**Response to NRC Comments on the
Cimarron Corporation
Final Status Survey Plan for Phase II Areas
for
Cimarron Corporation's
Former Nuclear Fuels Fabrication Facility
Crescent, Oklahoma**

**License No. SNM-928
Docket No. 70-0925**

January 28, 1997

**CIMARRON RESPONSES TO
NRC Staff Comments Dated October 31, 1996
on the "Final Status Survey Plan for Phase II Areas for
Cimarron Corporation's Former Nuclear Fuel Facility
at Crescent, Oklahoma."**

RESURVEY OF COAL BUILDING FLOOR

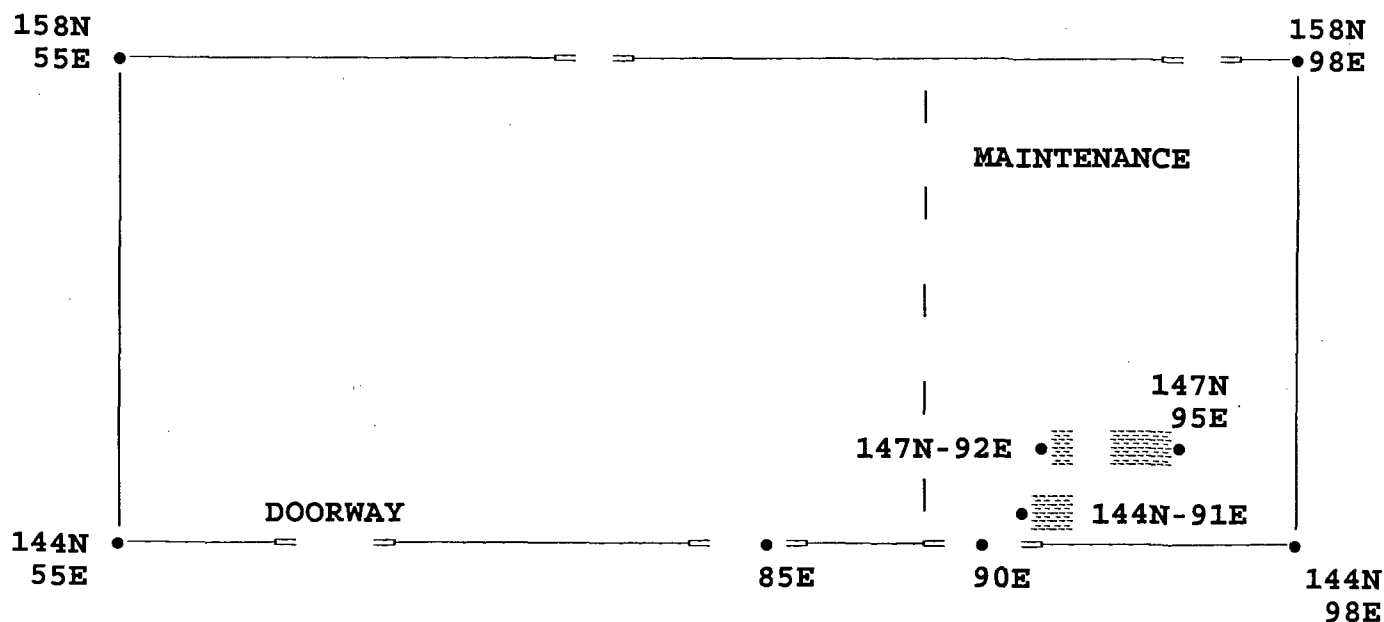
3. Section 6.3 (page 10) of the FSSP indicated that Warehouse Building #4 was never used to process radioactive materials. However, contamination was discovered (during additional surveys conducted in 1993) in several small areas, after the building was used for non-nuclear purposes. Please identify the source(s) of contamination on the floor of Warehouse Building #4. In addition, please define the extent of contamination.

Attachment 1 depicts where the beta contamination was located and provides a description of the survey results. The contamination was ostensibly tracked into Warehouse Building #4 from the Uranium Yard Area and from the Uranium Building. The Uranium Yard Area and the Uranium Building were the sources of the contamination. These beta activities ranged from an average of 760 dpm/100 cm² to a maximum of 1,430 dpm/100 cm².

THE COAL BUILDING FLOOR WAS SURVEYED IN 1993. THERE WERE THREE AREAS IN THE COAL MAINTENANCE SHOP THAT INDICATED ELEVATED DIRECT READINGS. THE AREAS WERE LOCATED NEAR THE SOUTH EXIT DOOR AT THE BASE OF TWO I-BEAMS (1-SQUARE FOOT AREA AROUND ONE I-BEAM AND ONE 2-SQUARE FOOT AREA AROUND THE OTHER I-BEAM) AND A 3-SQUARE FOOT AREA EAST OF THE I-BEAMS. THE THREE AREAS WERE DECONTAMINATED (NEEDLE GUNNED) AND THEN RE-SURVEYED. ALL READINGS WERE WELL BELOW THE RELEASE LIMITS (5000 DPM/100CM²) FOR BOTH ALPHA AND BETA. THESE THREE AREAS WERE RE-SURVEYED AGAIN ON JUNE 27, 1995 USING A LUDLUM MODEL 177 INSTRUMENT IN ORDER TO ENSURE THAT THESE AREAS WERE FREE OF CONTAMINATION. THE RESULTS OF THESE SURVEYS ARE LISTED BELOW.
